The Commission has issued the enclosed Amendment Nos. 110 and 113 to Facility Operating License Nos. DPR-24 and DPR-27 for the Point Beach Nuclear Plant, Unit Nos. 1 and 2. The amendments consist of changes to the Technical Specifications in response to your application dated April 10, 1986, as revised by your July 17, 1987 letter.

ATTACHMENT TO LICENSE AMENDMENT NOS. 110 AND 113
TO FACILITY OPERATING LICENSE NOS. DPR-24 AND DPR-27
DOCKET NOS. 50-266 AND 50-301

WISCONSIN ELECTRIC POWER COMPANY
POINT BEACH NUCLEAR PLANT, UNIT NOS. 1 AND 2
DOCKET NOS. 50-266 AND 50-301

| <u>REMOVE</u> | <u>INSERT</u> |
|------------------------|------------------------|
| Figure 15.6.2-2 | Figure 15.6.2-2 |

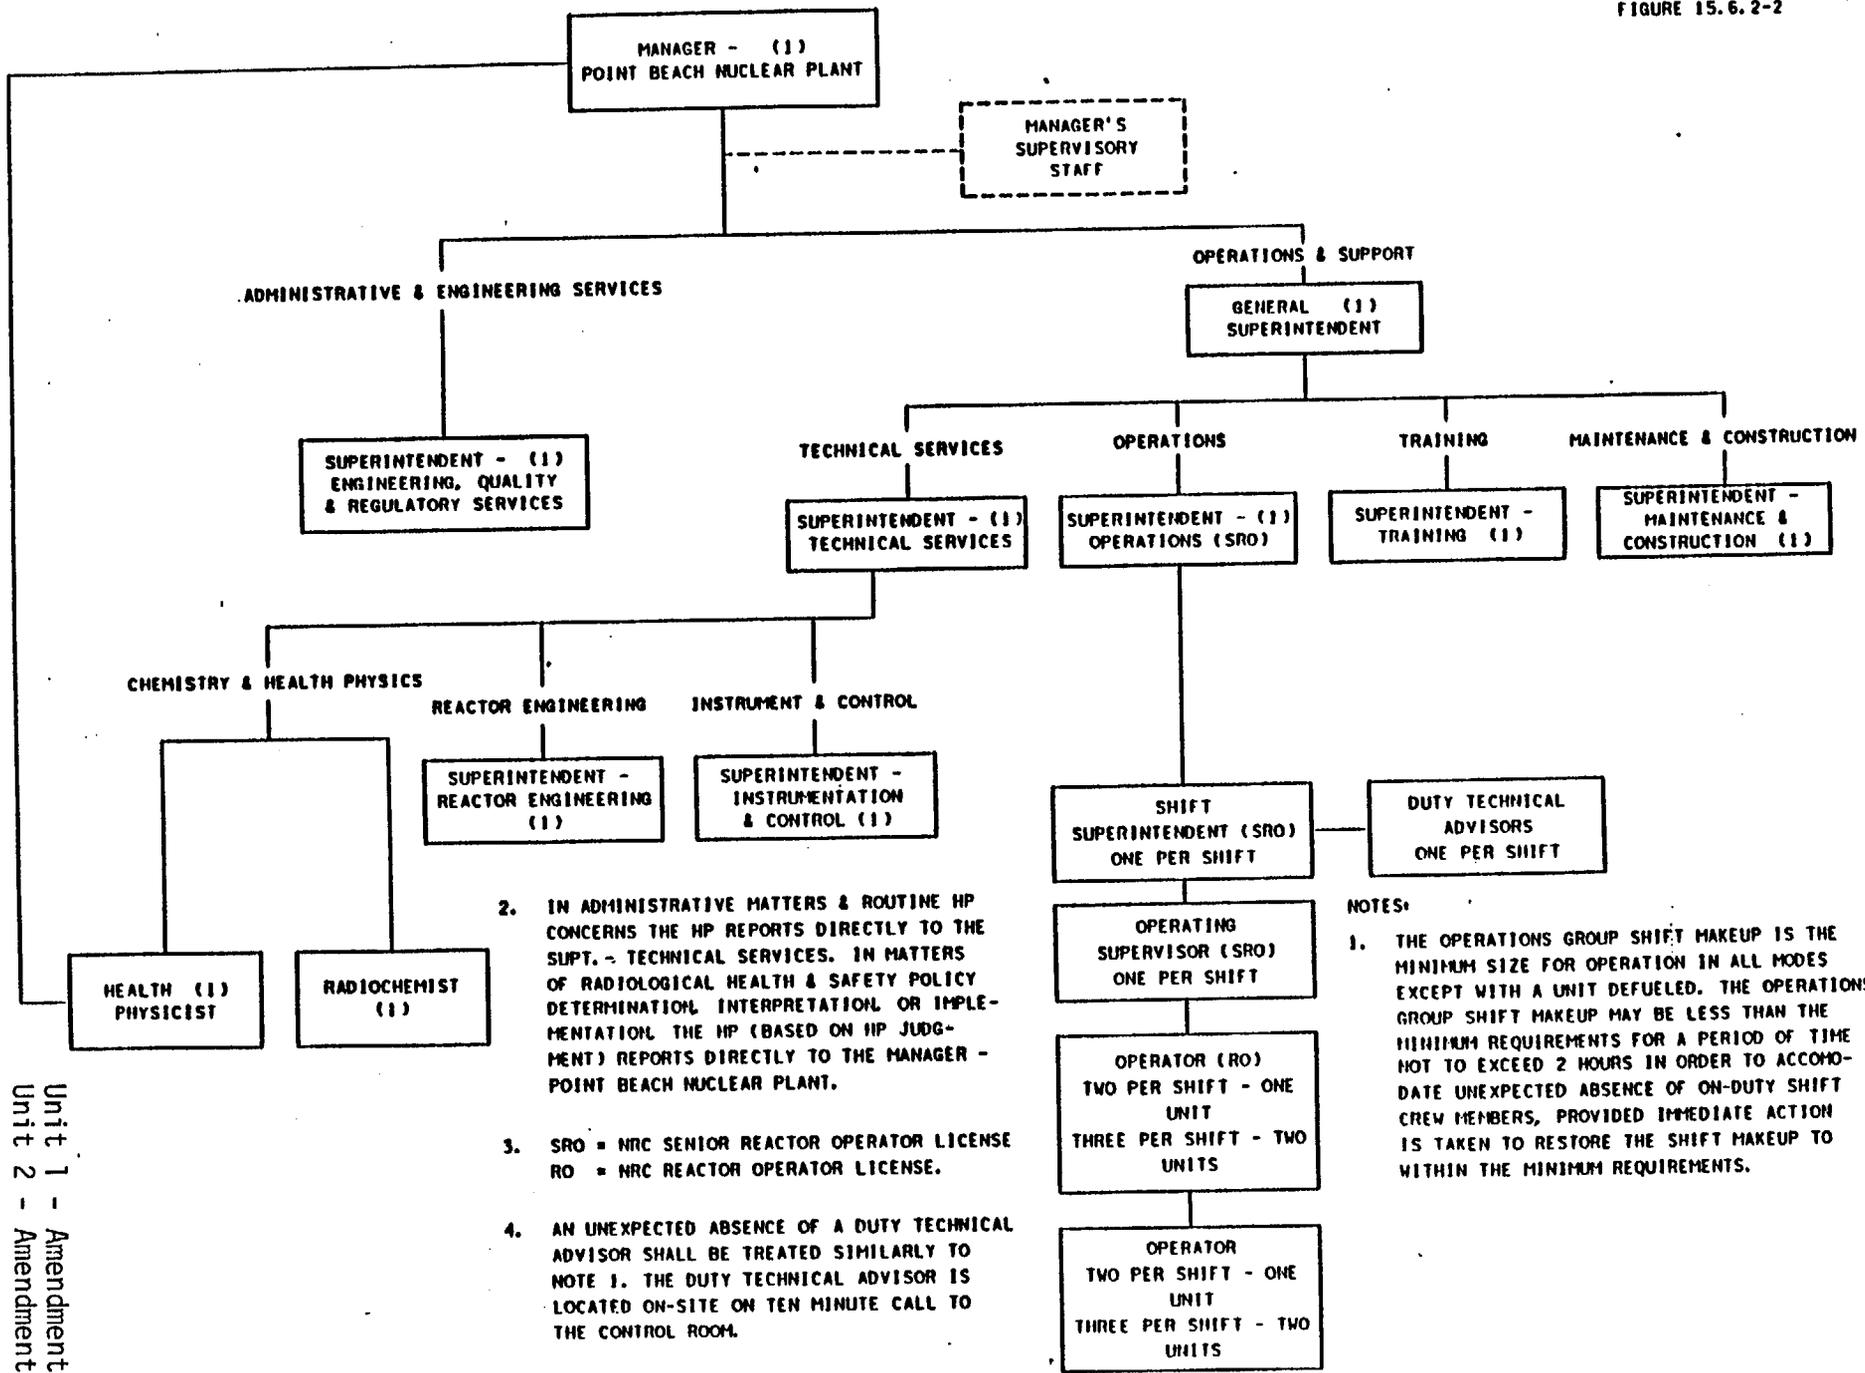
- TS 15.6.3.2, 15.6.3.3, 15.6.5.1.2 and figure 15.6.2-2 will be revised to reflect a reorganization which eliminated the position of Superintendent-Chemistry and Health Physics. The revision also designated the position of Radiochemist as being a regular member of the Point Beach Manager's Supervisory Staff.
- The wording of TS 15.7.8.1 will be changed from "responsibilities" to "duties". This will make this specification compatible with the referenced specification.
- TS 15.4.4.III.B, 15.6.9.1.B.2.a, and Table 15.3.5-5, Items 7 and 13 will be revised to correct erroneous references to other specifications.
- The basis of T.S.15.4.5 will be rewritten to remove ambiguities existing in the present wording.
- References to "FFDSAR" will be changed to "FSAR" on pages 15.1-2, 15.3.1-14A, 15.4.6-2, 15.6.9-1, and 15.6.10-1.
